# Pacific Blue (Jeans Wear) Ltd.

Radio Colony, Savar, Dhaka

# Observations

Column and RC wall layout plan

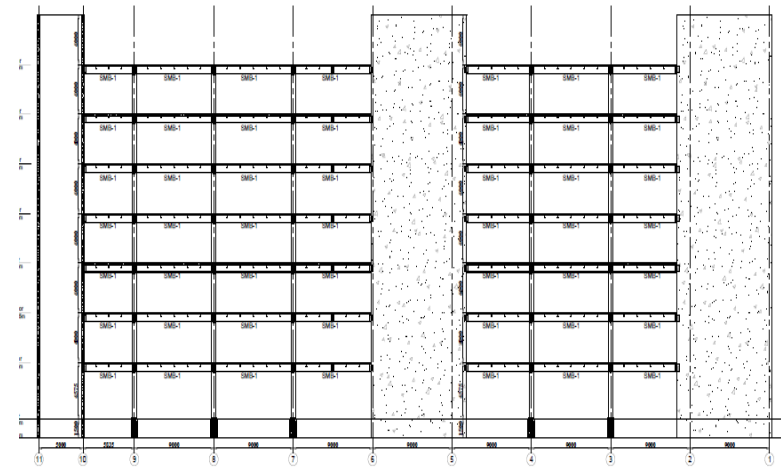
Steel beams in the several grids are connected to the shear walls. Design report was not available to determine the contribution of RC wall and diaphragm action in lateral stability system.

Building engineer is required to check the overall stability system and the connections.

Typical floor layout plan

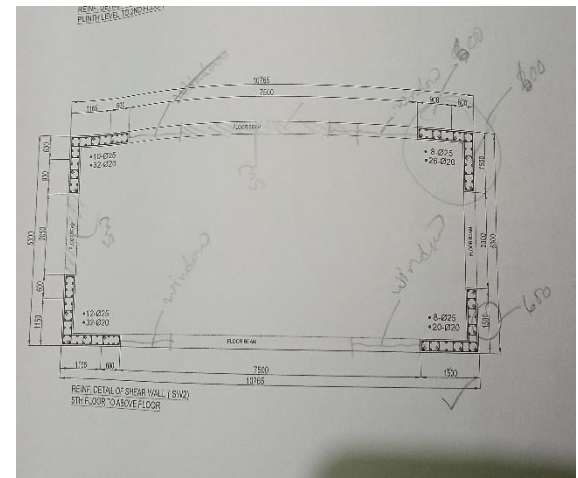
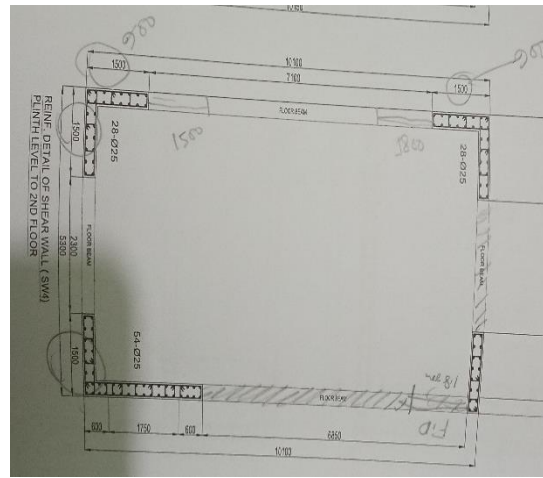
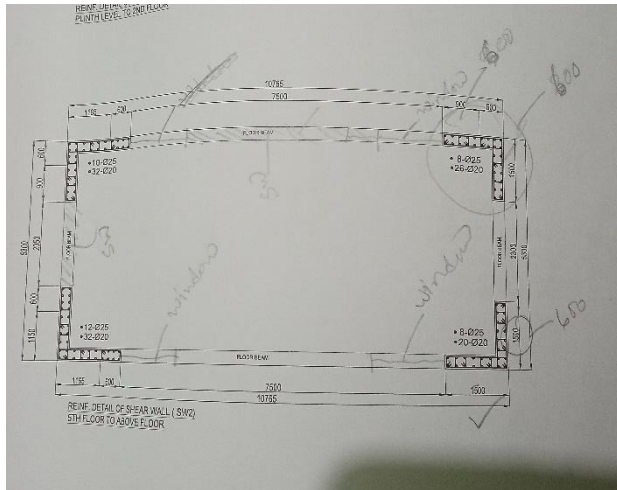
As per BNBC, every building or structure designed shall have its design documents prepared in accordance with the provision of Section 1.9.1. The design document shall include a design report, and a set of structural drawings, which shall be prepared in compliance with section 1.9.1.1 and section 1.9.1.2 of part-6, BNBC. However, design report was not available during inspection. The building engineer is required to prepare a design report in compliance with BNBC.

## Inconsistency in dimension of lift shear wall core

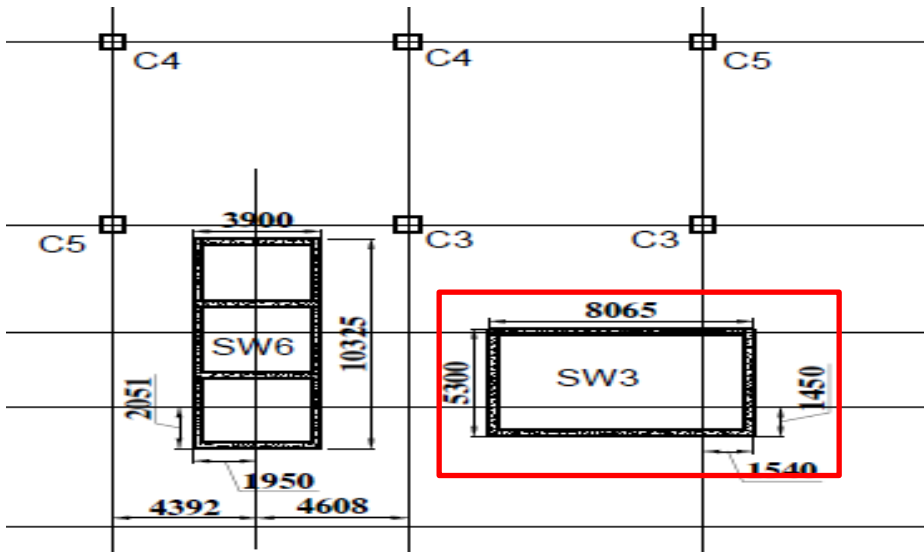
Dimension of lift core doesn't match with the existing condition. Structural details of SW-3 not shown in the structural drawings. The building engineer is required to survey the structural components and produce accurate structural details & as built drawings.

No details of SW-3

5th floor plan (production) 3 kPa considered in the load plan

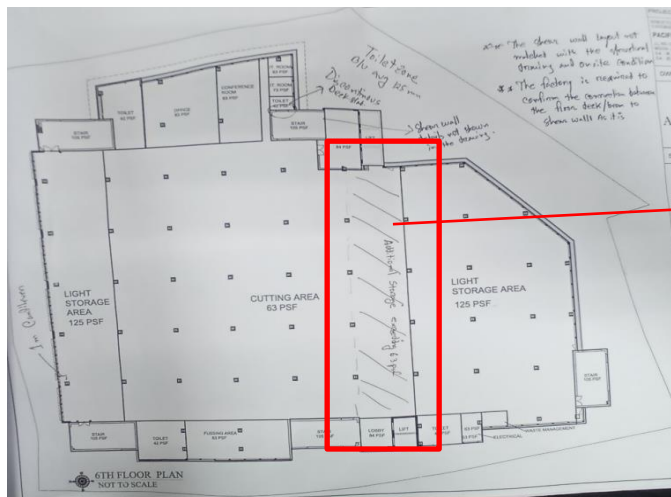
Onsite storage observed on the 5th floor

Onsite storage observed on the 6th floor.

On the 5th and 6th floor storage was observed on production area (3kPa). The building engineer is required to check the occupancies and update the floor live loading plan for all floors based on BNBC requirements and manage the floor loading accordingly.
